From:
To: [Edward Freedman](#); [Helen Webster](#)
Subject: FW: Atkinsons Wood Farm, Easby - Revised Plans
Date: 13 November 2018 16:17:06
Attachments:

Further to our ongoing discussions concerning Atkinsons Wood Farmhouse, please find attached a suite of revised plans, responding to the various issues we recently discussed.

Client:		G Yewdall	
Project:		Proposed Alterations to Listed Building Atkinsons Wood Farm, Easby	
Drawing:		Proposed Doors and Windows	
Status:	for Approval	Date:	25 March 2018
Drawn by:	djh	Checked by:	
Scale:	1:20@A1	Role:	
Project No:	17056	System:	ZZ XX
Originator:	SPA	Location:	DR
Volume:		Type:	A
Level:		Role:	[30] 01
Subsidiary:	S3	Subsidiary Description:	for Planning Approval
Rev:		Rev:	P03

Drawing:
Scheme Design
Proposed Plans & Elevations

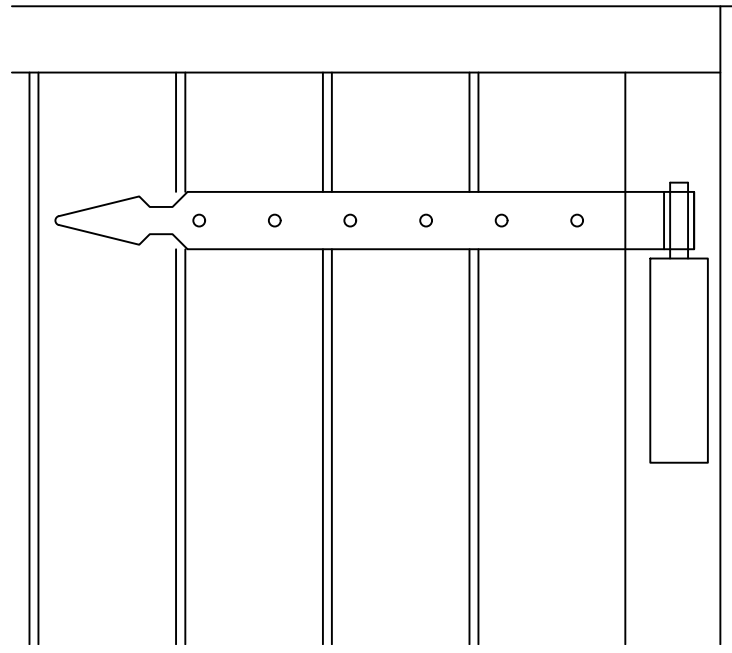
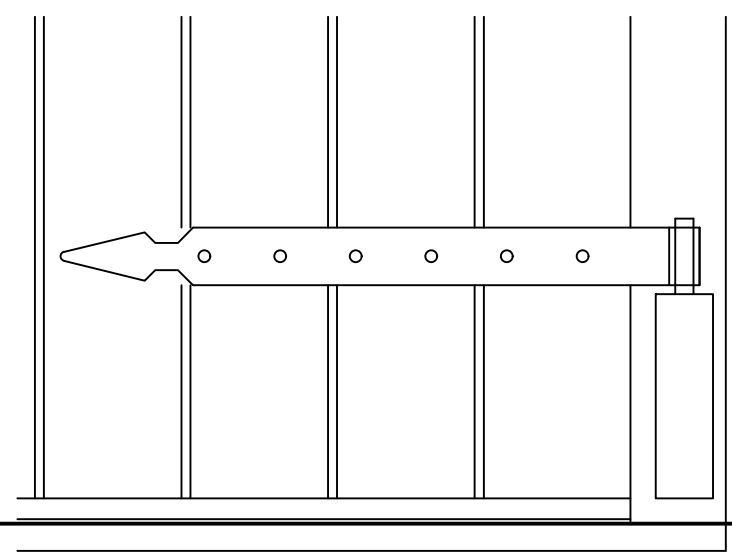
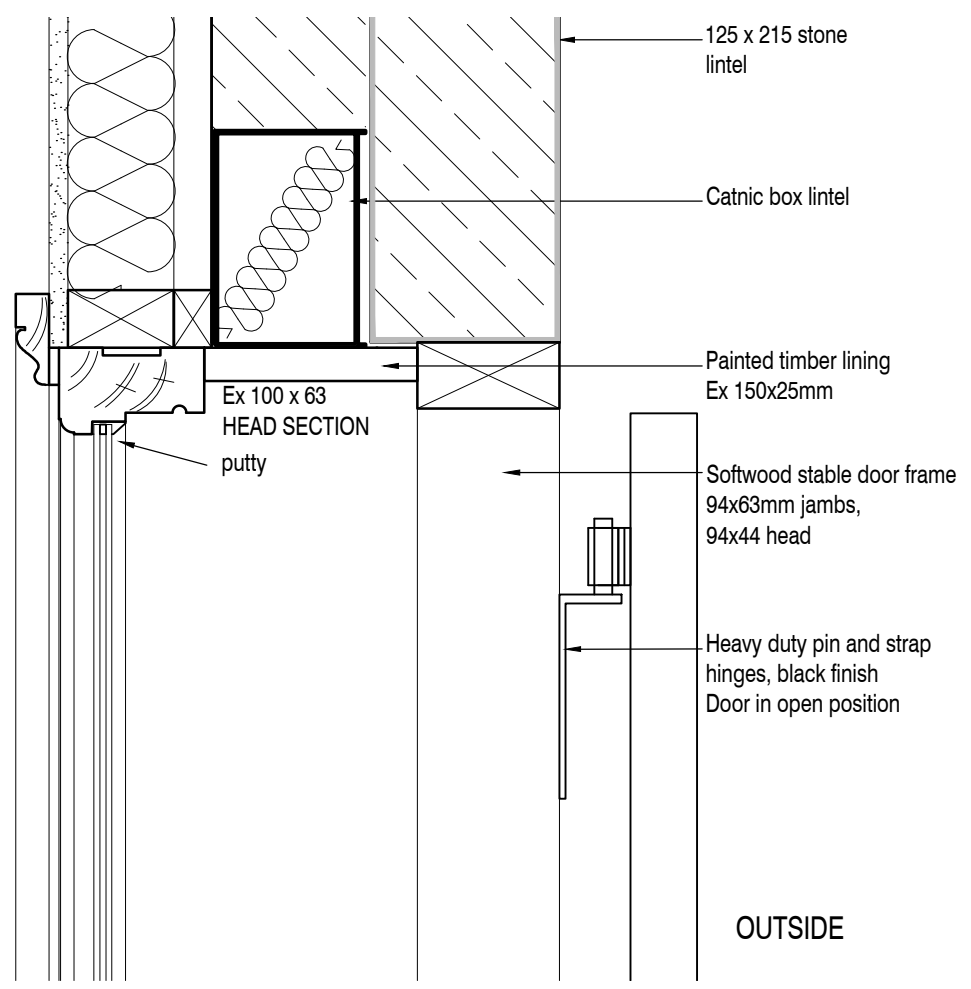
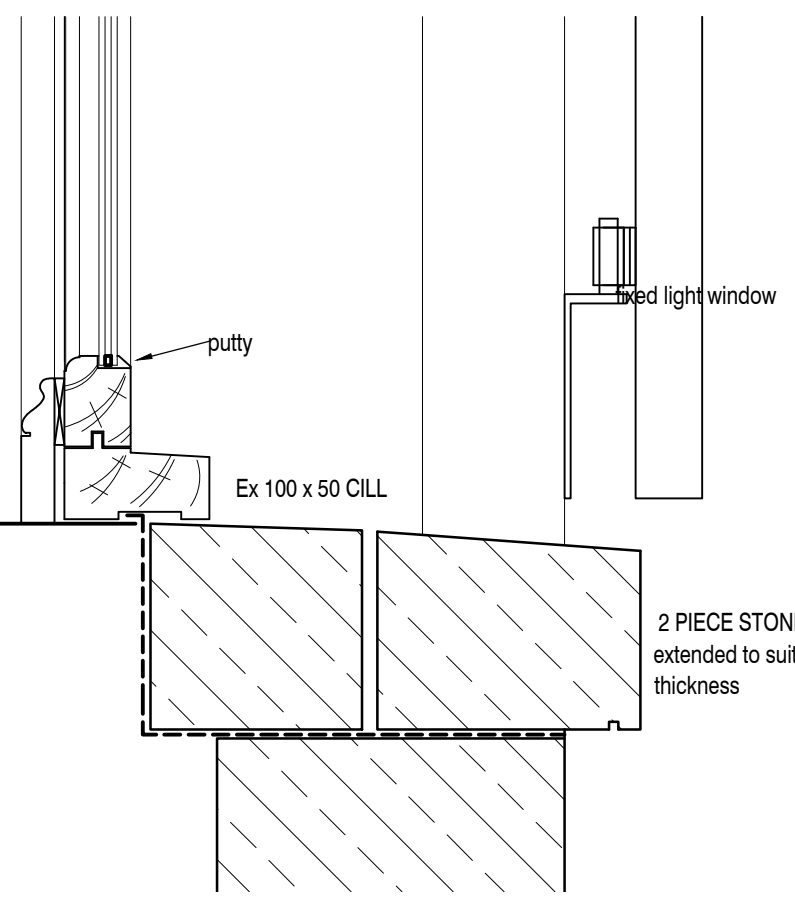
It looks from photos as though all of the original barn and stable door pin hinges have been lost over time so we have drawn new frames for stable doors with pin hinges and straps fixed to timber frames. That would mean two timber frames in those openings with the window at the back and the stable door at the outside face of the walls as drawn.

An alternative would be to hang them on pin hinges built into the masonry walls as the original ones were and not onto a new frame inside the opening. The tricky thing with built in hinges would be to get them accurately in alignment so that the stable doors hang plumb. Photo of the alternative built in pin hinge attached for information. We await your feedback and thoughts on this specific point.

DETAILS APPLY FOR GW05, GW06, GW08, GW18 WITH WINDOW AT INTERNAL MASONRY FACE AND STABLE DOOR AT EXTERIOR WALL FACE
GW02 WINDOW IS SIMILAR BUT WITH EXTERIOR SLIDING DOORS

GW04 WITH sliding doors GD02

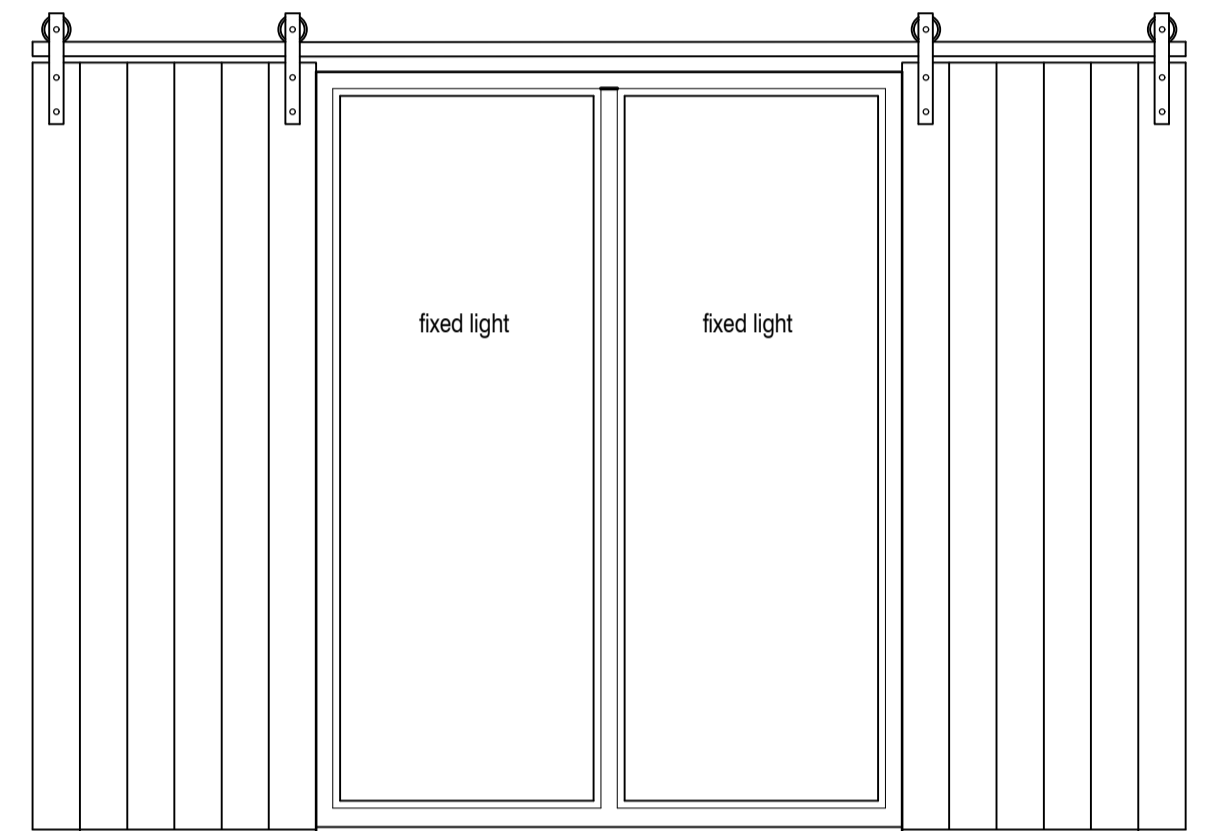
1. Double hung sashes revised to side hung flush casements for windows GW01, GW13, GW14, GW16, GW17
2. GW18 now has stable door added as with other barn door sized openings.
3. FW09 corrected to match elevation
4. Sliding doors added on detail elevation drawing for GD02
5. Sunroom and porch omitted together with door GD07
6. GD08 now repositioned to end of extension and with boiler room now renamed as porch. GW20 added at location of porch.
7. Detail drawing added for situations where there is a window in line with back of the masonry wall and stable doors fixed at the outside wall face. I have proposed simple 'farm' type hardware to the stable doors and sliding doors.
8. Elevations and plans revised to suit the above. GD 06 retained as external back door to Hall.
